FIELD REVISION
MSHA APPROVAL: Chris Strain
DATE: 10/26/04

REVISIONS	
A	4-30-03 REBUILD TRAFFIC SIGNAL DUE TO GEOMETRIC CHANGES SHA NO.: BW99GMR2 TIMS # F416 — RRZ

MD 32 (SYKESVILLE RD) AND BURNTWOODS ROAD/ANDREA DRIVE

DRAWN BY: SR BARANOWSKI	F.A.P. NO.		TS NO. 3258A	SHEET NO. 1 OF 3
CHECKED BY:	S.H.A. NO.	HO-744-509-785		
SCALE: 1"= 20'	COUNTY:	HOWARD	T.I.M.S. NO. F416	
DATE: 11-11-92	LOG MILE:	13003216.56

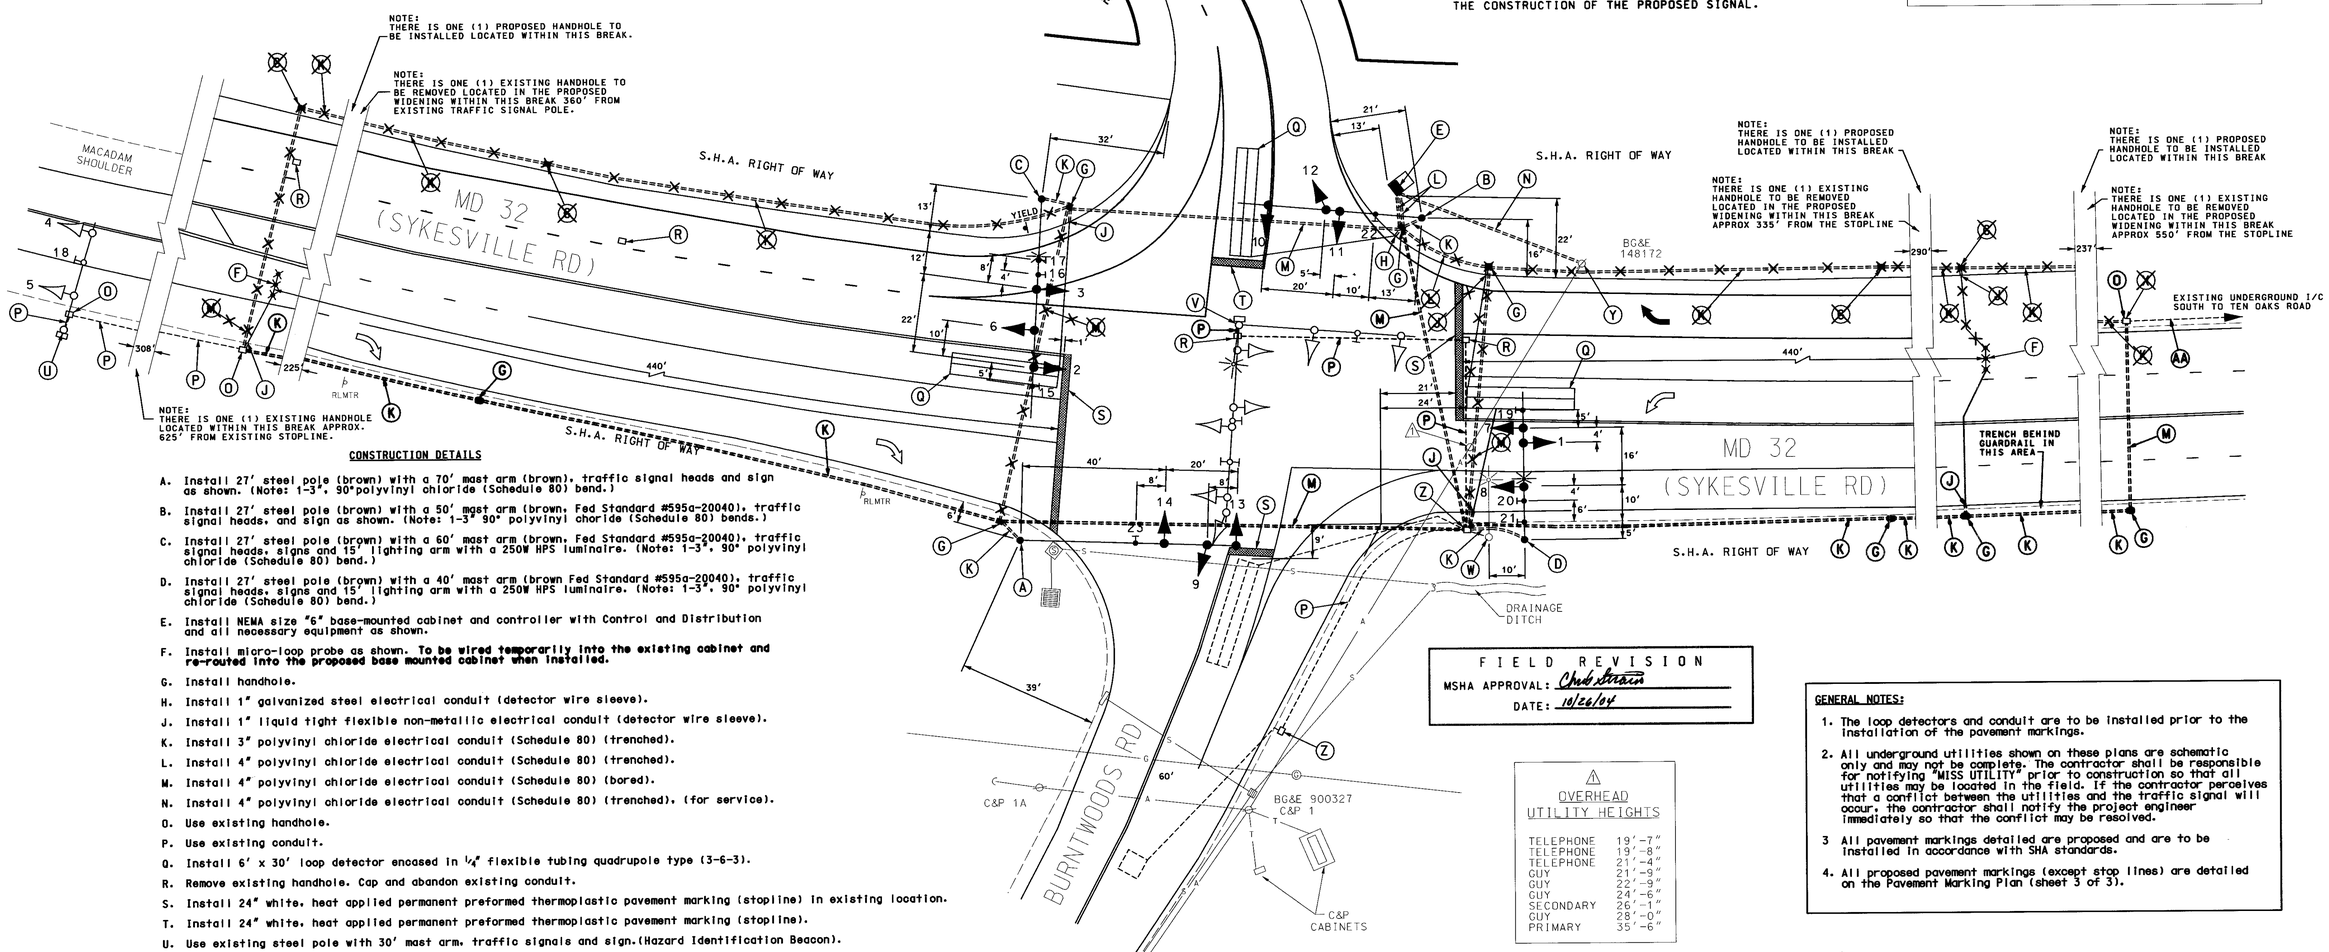
NOTES:
THIS REVISION INVOLVES RELOCATING THE PROPOSED CONDUIT TO THE WEST SIDE OF MD 32. THE ADVANCE DETECTION (PROBES). THE N.B. MD 32 LEFT TURN DETECTION AND INTERCONNECT TO THE SIGNAL AT TEN OAKS ROAD MUST ALL BE MAINTAINED THROUGHOUT THE CONSTRUCTION OF THE PROPOSED SIGNAL.

F. Install micro-loop probe as shown. **To be wired temporarily into the existing cabinet and re-routed into the proposed base mounted cabinet when installed.**

~~X. Disconnect existing interconnect cable in the existing cabinet at Burntwoods Road and pull back to this handhole located approximately 720' from the stopline on northbound MD 32. Reroute through the proposed conduit into the new base-mounted cabinet.~~

AA. Maintain existing conduit to the cabinet at Ten Oakes Road. Install new 12-pair interconnect from Ten Oaks to the existing cabinet at Burntwoods. Loop 8' of additional interconnect cable in each handhole to be used when the proposed base mounted cabinet at Burntwoods is installed. Remove old interconnect cable. (See Wiring Diagram).

BB. Install 6' x 30' loop detector encased in 1/4" flexible tubing quadrupole type (3-6-3).To be wired temporarily into the existing cabinet and re-routed into the proposed base mounted cabinet when installed.
